QUESTIONS ON BID DOCUMENTS (QBD)

Project: PIER 80 MOORING AND BERTHING
IMPROVEMENTS

Contract No. 2871

SAN FRANCISCO PORT AUTHORITY
PORT OF SAN FRANCISCO
DEPARTMENT OF ENGINEERING
ARMY ST. TERMINAL
DECK & FINISHED GRADE PLAN
IN CHARGE OF W.F.M. CHECKED BY P.T.M.
MADE BY K.A.B. R.V.S. DATE 7-10-63
TRACED BY R.V.S. SCALE 1"=60'
DRAWING NO. 6948-86-1 SHEET NO. 17 OF 33

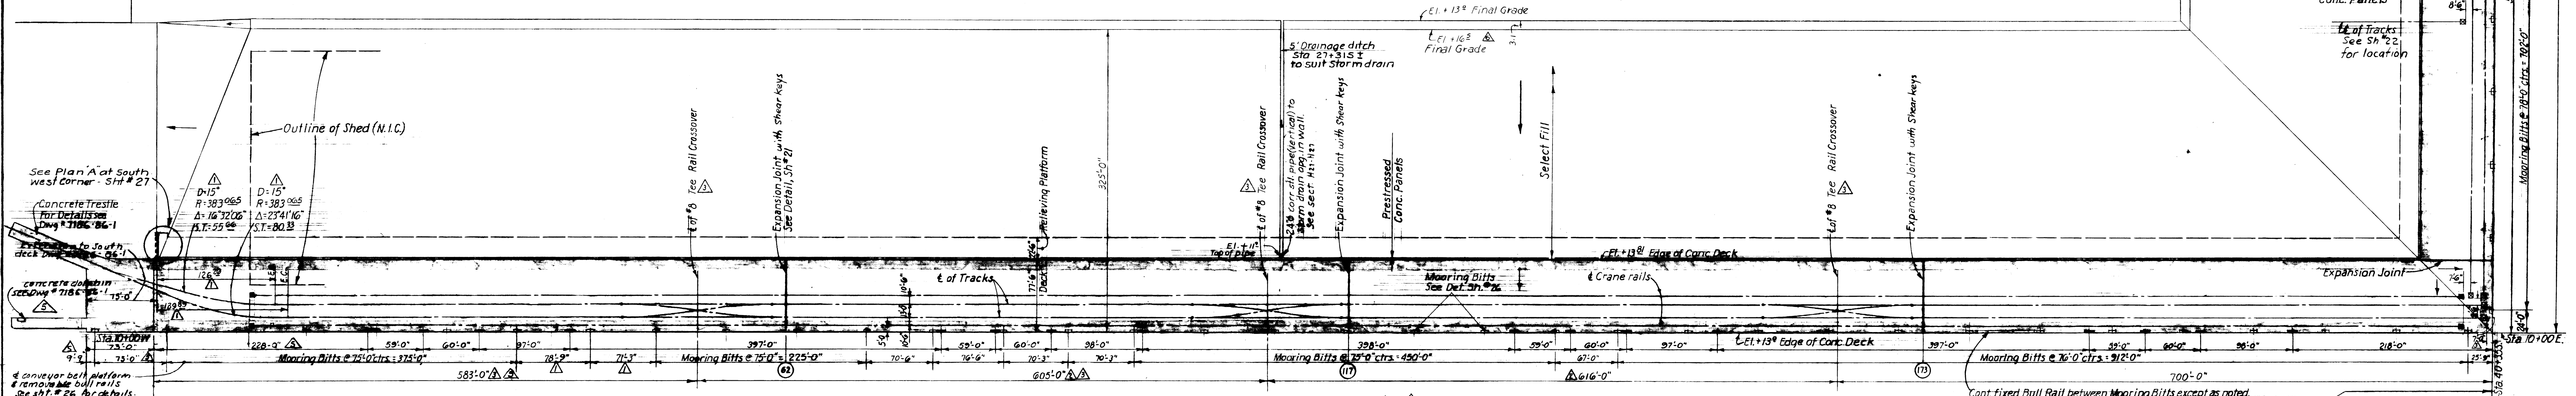
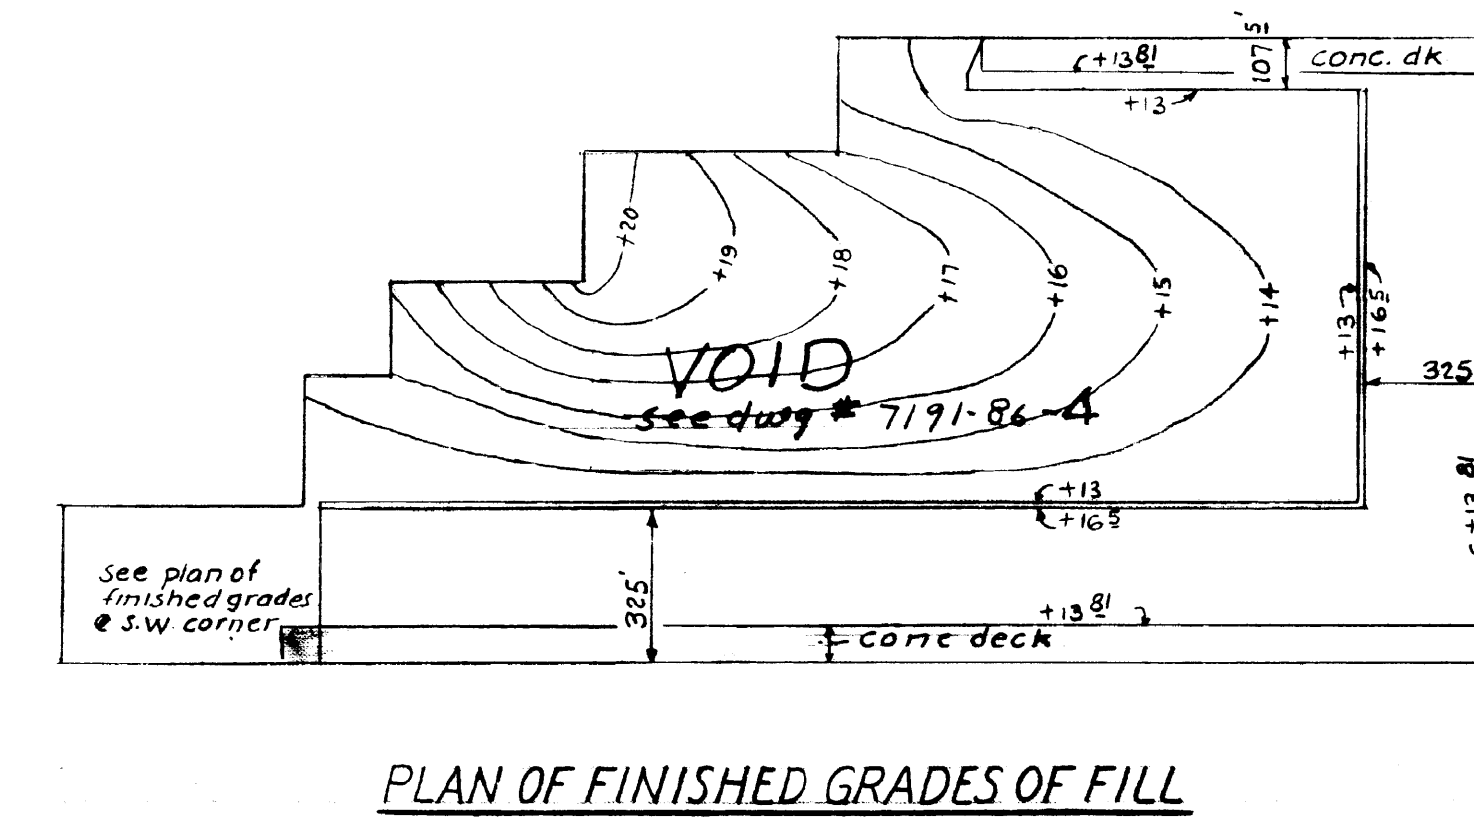
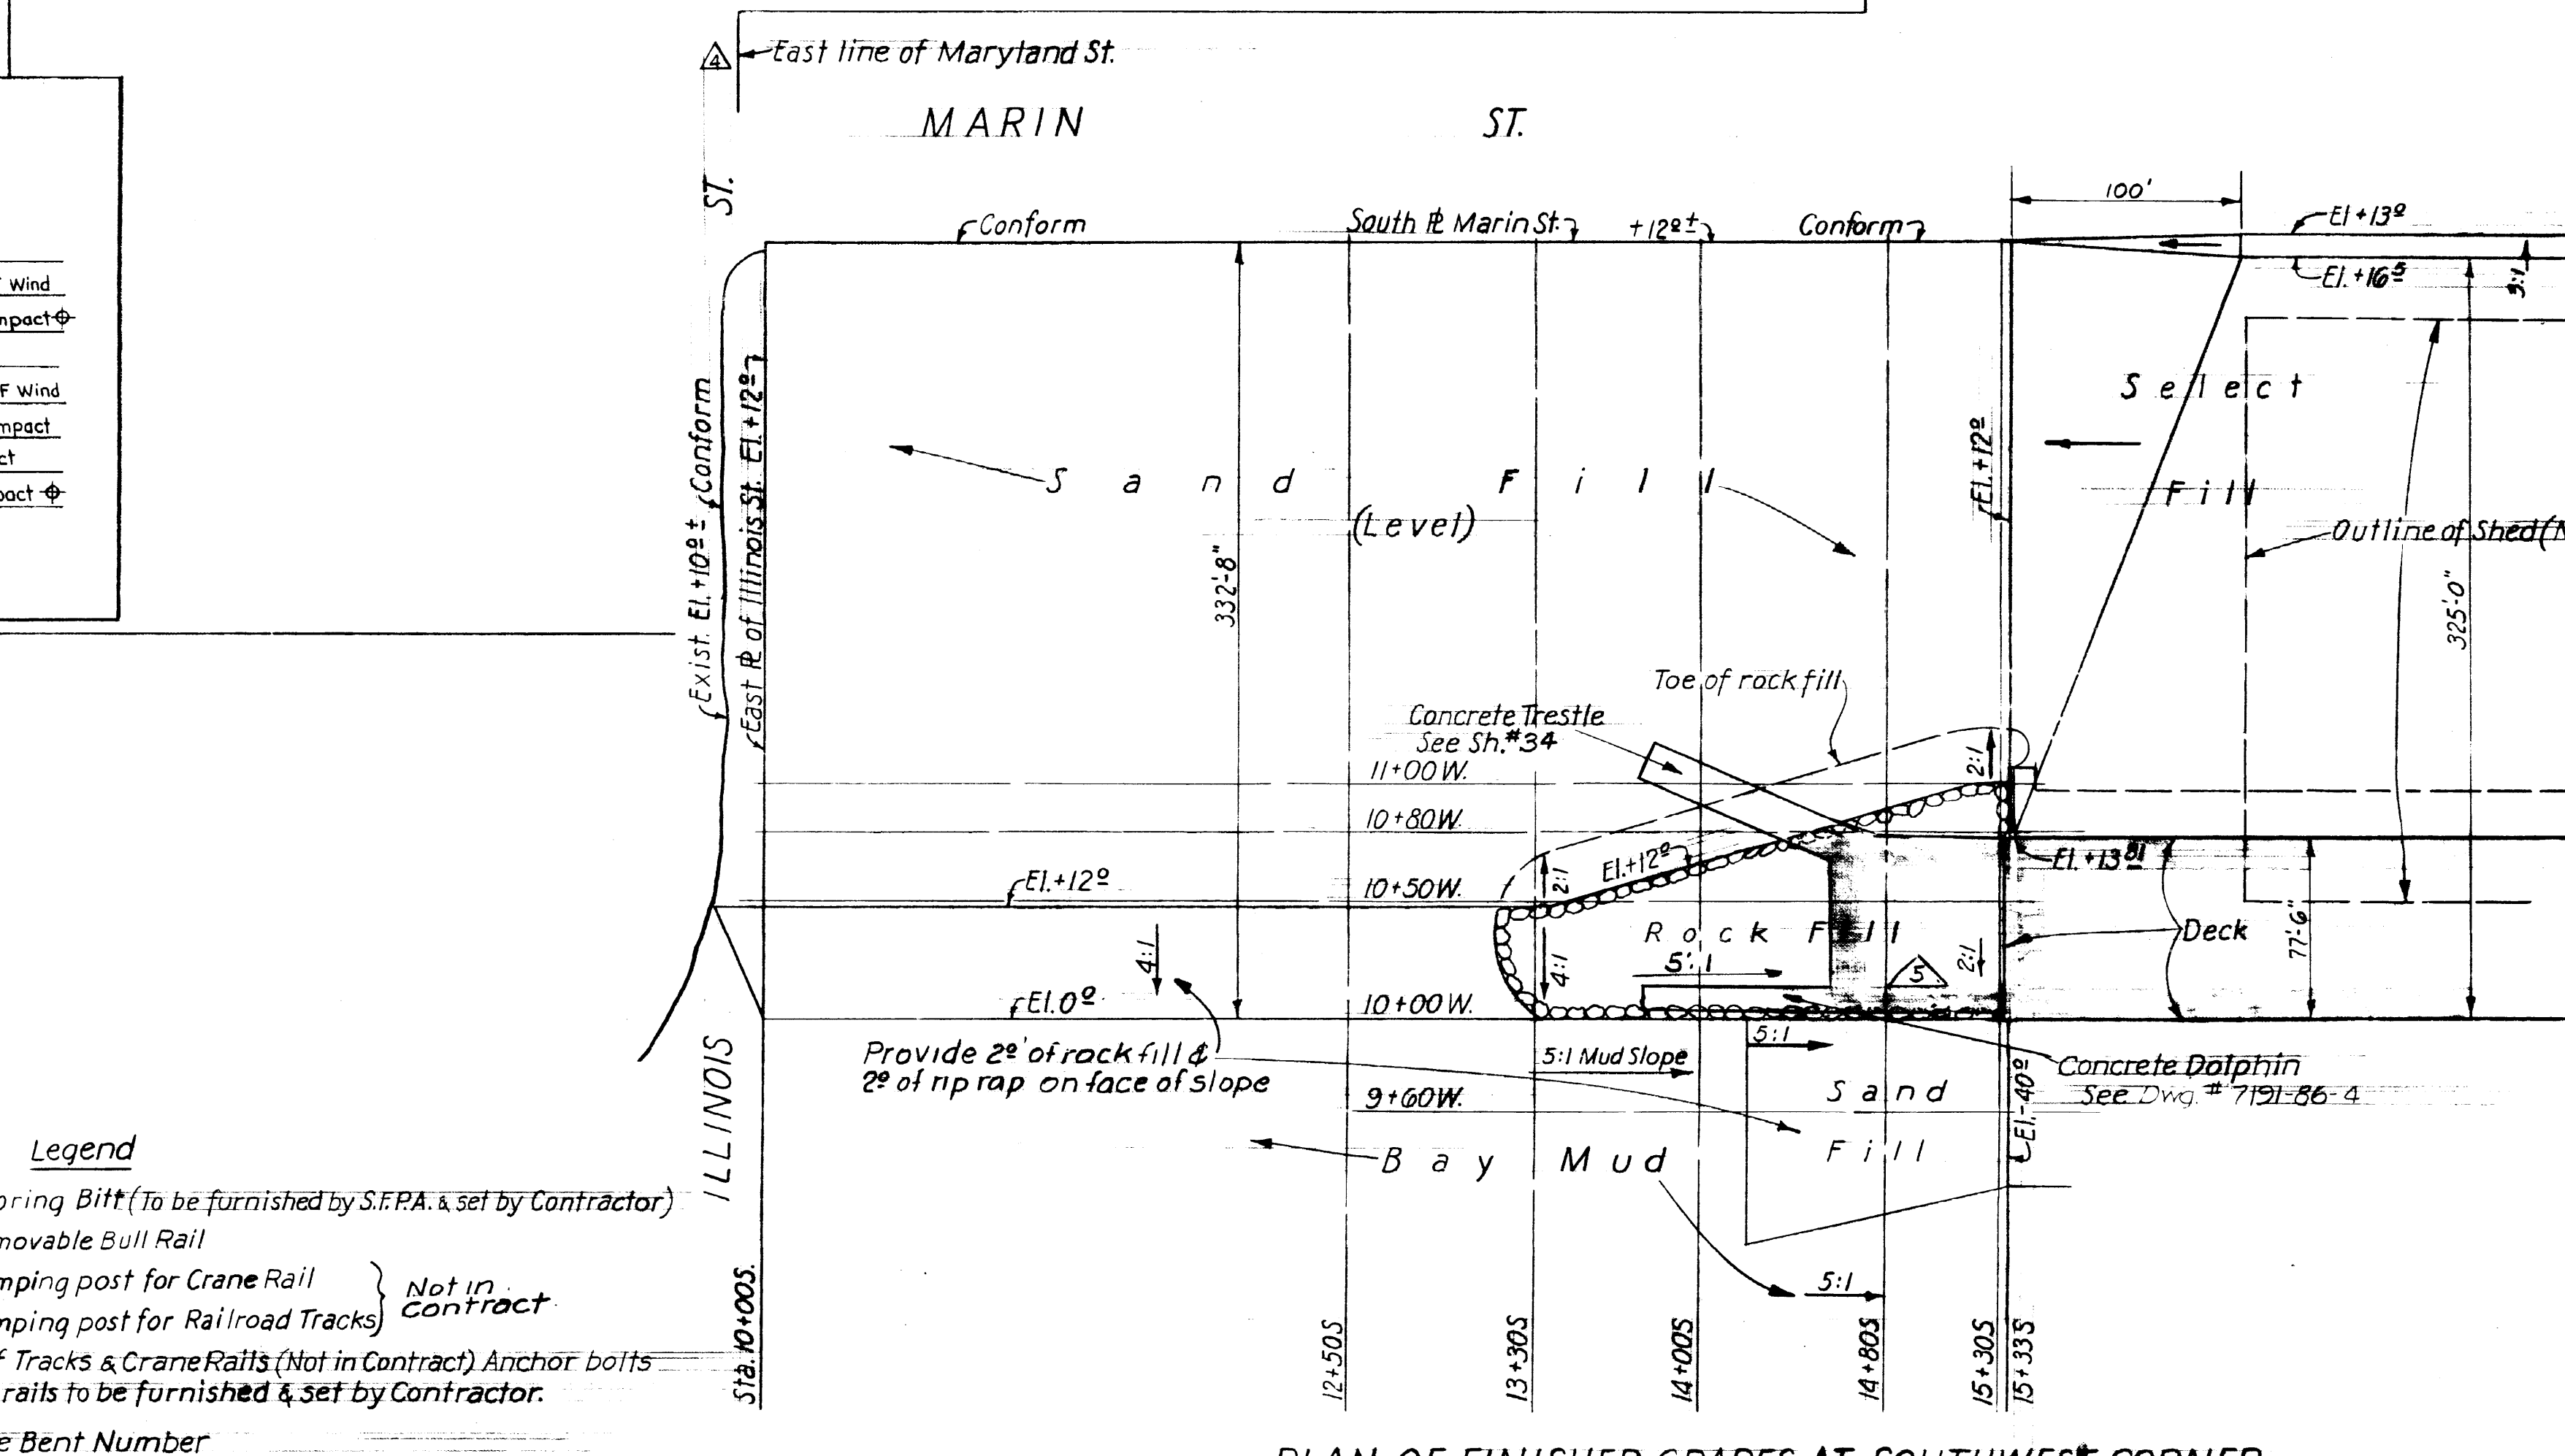
CONTRACTOR'S QUESTIONS	
Company Name:	THE DUTRA GROUP
Contact Name:	ESTIMATING
Title:	
Date	3-26-25
Tel:	415-258-6876
Fax:	
Check One Only (Use separate form for each specifications and drawing question.)	
<input type="checkbox"/> Spec. Section:	Paragraph(s):
<input checked="" type="checkbox"/> Drawing Sheet:	Detail(s):
<p>Question: PLEASE CONFIRM THAT THE PIER DECK ADJACENT TO AND WITHIN THE WORK ZONE IS AVAILABLE FOR THE CONTRACTOR'S USE, INCLUDING TO STAGE HEAVY EQUIPMENT SUCH AS CRANES AND TO STOCKPILE DEMO DEBRIS. PLEASE CONFIRM THE LOADING CAPACITY OF THE PIER DECK IN THE WORK ZONE.</p>

CITY'S REPLY	
<input type="checkbox"/> Mark this box if the QBD can be answered by Bidder's review of the documents. Reply with location(s) where the information can be obtained.	
<p>Pier deck and adjacent area is available for contractors use. However, the contractor must vacate and clear areas as directed by the Port representative at no additional cost during tenant operation days. Port Tenant's vessel will drop a ramp near the north side of berth C (East Berth) and contractor shall keep area clear during tenant operations. Main staging and storage area is shown on sheet S101. Additional storage and stockpile shall be coordinated with the Port in conjunction with Port Tenants. Design loads are shown in the available building documents titled "Army St. Terminal General Plans" on page 5. Also attached to this QBD response for convenience. There is a localized area on the east berth roughly 10'x10' in dimension experiencing concrete spalling under deck that may require load limitations. Exact area to be determined before mobilization.</p>
